EXETER  
COLLEGE  
OXFORD

A New Quad at Walton Street  
**Supplementary Planning Document**  
July 2013

This addendum statement responds to the issues arising from the recent statutory consultation process, as well as the consultation undertaken by Exeter College directly, in support of the statutory processes.

The addendum report is a formal submission to Oxford City Council and should be read in conjunction with the applications new paragraph 13/00832/FUL for “Redevelopment of existing student accommodation and teaching site comprising the demolition of all buildings, with exception of the 1913 Ruskin College facade to Walton Street and Worcester Place, and erection of 90 student study rooms, 3 Fellows/Staff residential rooms, teaching facilities, library archive, social space, landscaping and associated works”; and 13/01075/LBD for “External alterations involving demolition of south and west facades of 1913 building, demolition of 1930’s, 1960’s and 1980’s extensions, and removal of existing roof. Erection of four storey extension to rear to provide 90 student study rooms, 3 Fellows/Staff residential rooms, teaching/lecture facilities, library archive and social space. Erecti

Fabric Intervention to achieve full Accessibility Key:

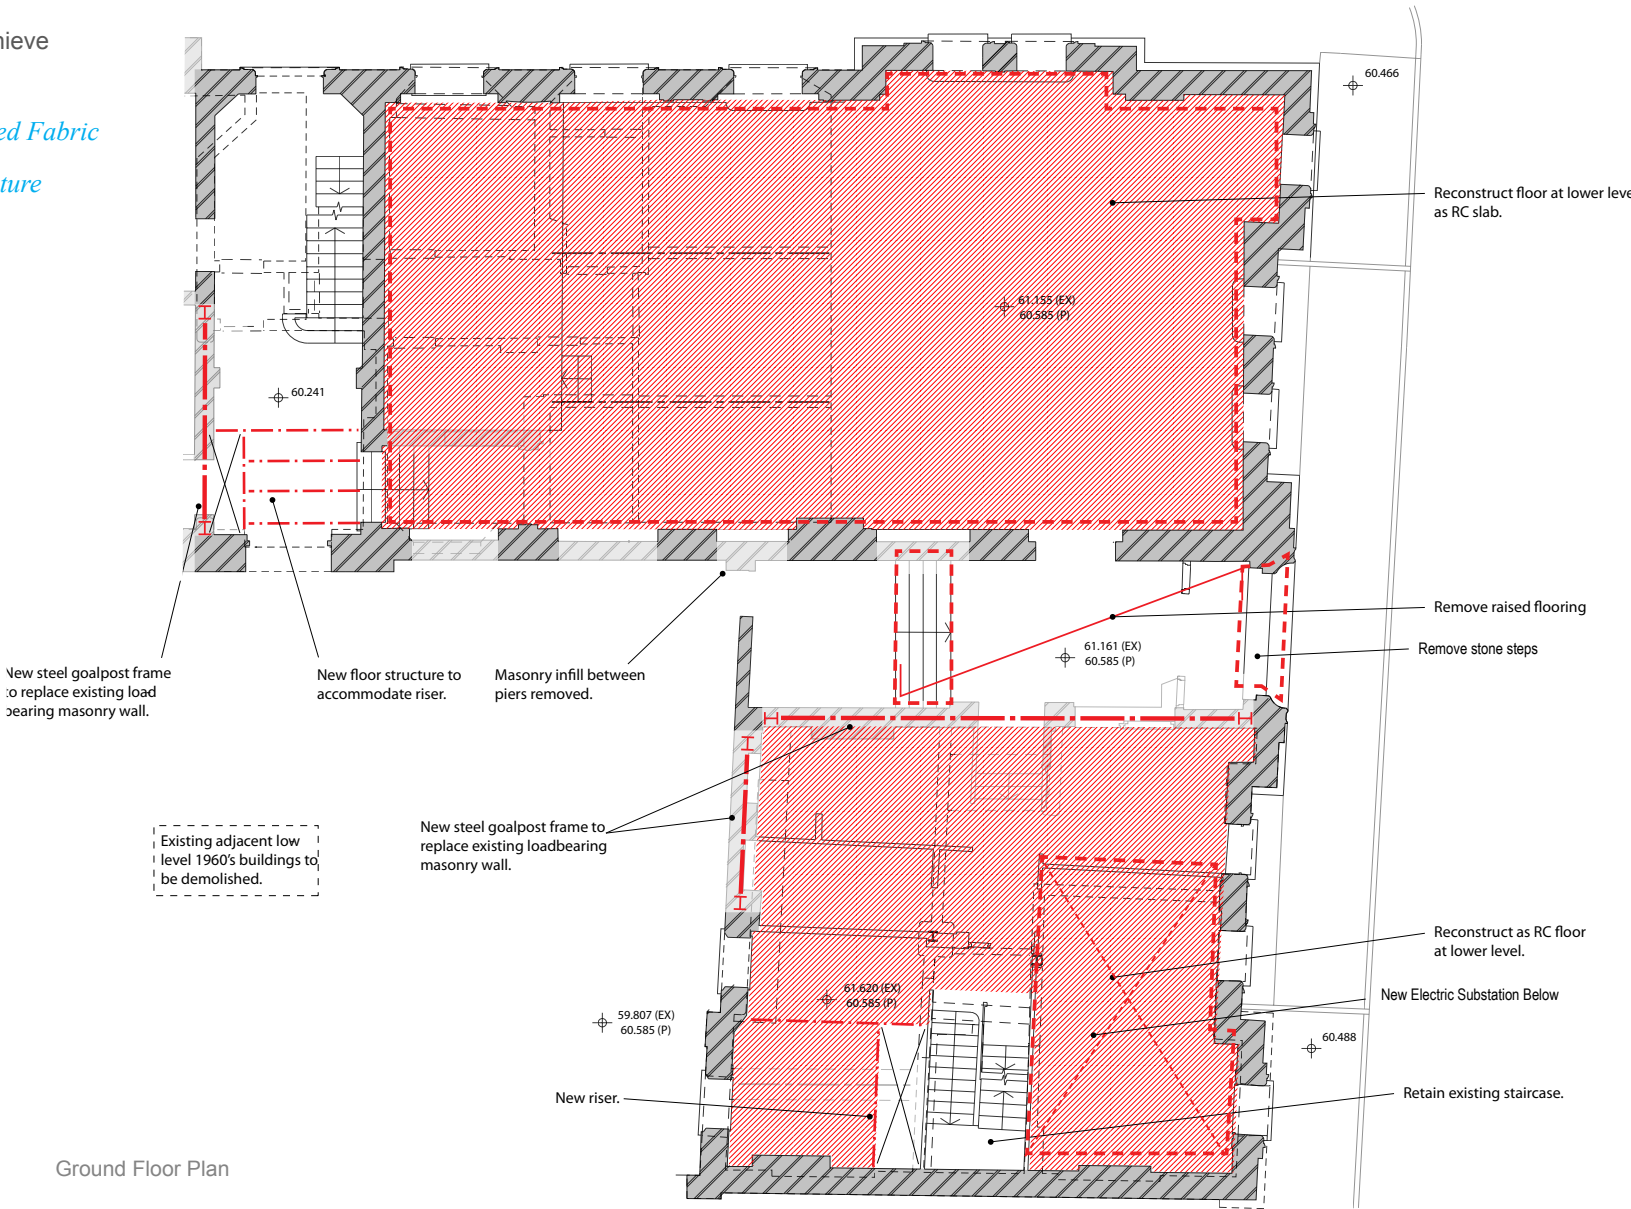
Whilst developing initial plans for the site, the Design Team quickly became aware of the fact that in order to provide the facilities and associated servicing required within the College's brief, a high proportion of the existing internal fabric would become compromised or would be lost completely. This servicing is vital to ensuring a suitable and viable scheme which meets the College's needs.

It should be noted that in English Heritage's correspondence, dated 16 May 2013, it is recognised that whilst internal alterations to accommodate modern servicing requirements are feasible, and could retain aspects of the floor plan, the existing steel frame would be particularly unforgiving of small adjustments, necessitating much more wide-ranging changes. As such English Heritage accepts that, at the end of this operation, it is true that relatively little might survive of the sense of how Ruskin was inhabited and used'. Retention of individual sections would also add significant costs, as well as compromising the final scheme, thus potentially making it unviable.

Fabric Intervention to achieve fit for purpose student accommodation **Key:**

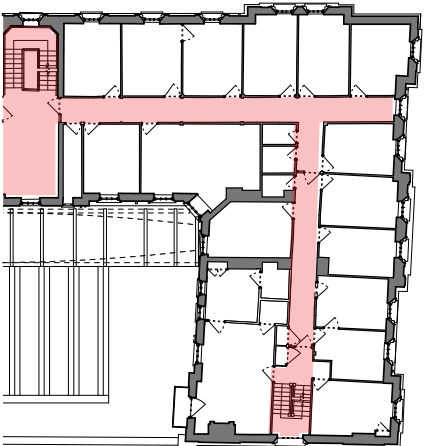
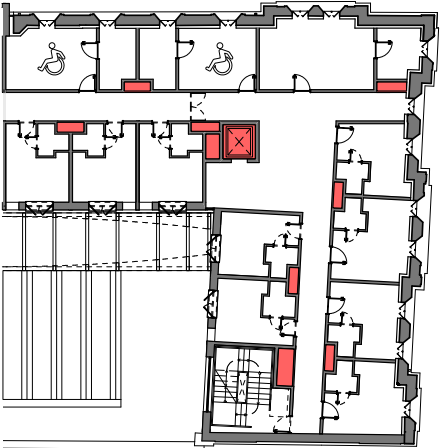
In order to meet the demands and expectations of modern 21st century students in Oxford it is crucial that the College is able to provide fit-for-purpose facilities and student rooms. This involves providing ensuite facilities and meeting certain space standards, enlarging the current student bedrooms which are well below the size offered by neighbouring colleges.

30 Undersized Student Rooms (11 SqM)  
Non Compliant Corridors  
Fire Escape Compromised  
No En suite Facilities  
Not Accessible

37 Full sized en suite Student Rooms (15 SqM)  
100% Disabled Access  
2 DDA Student Rooms per Floor  
Lift Access  
Compliant Stairs  
Improved Environmental Performance  
Relationship of floorplan to windows retained.
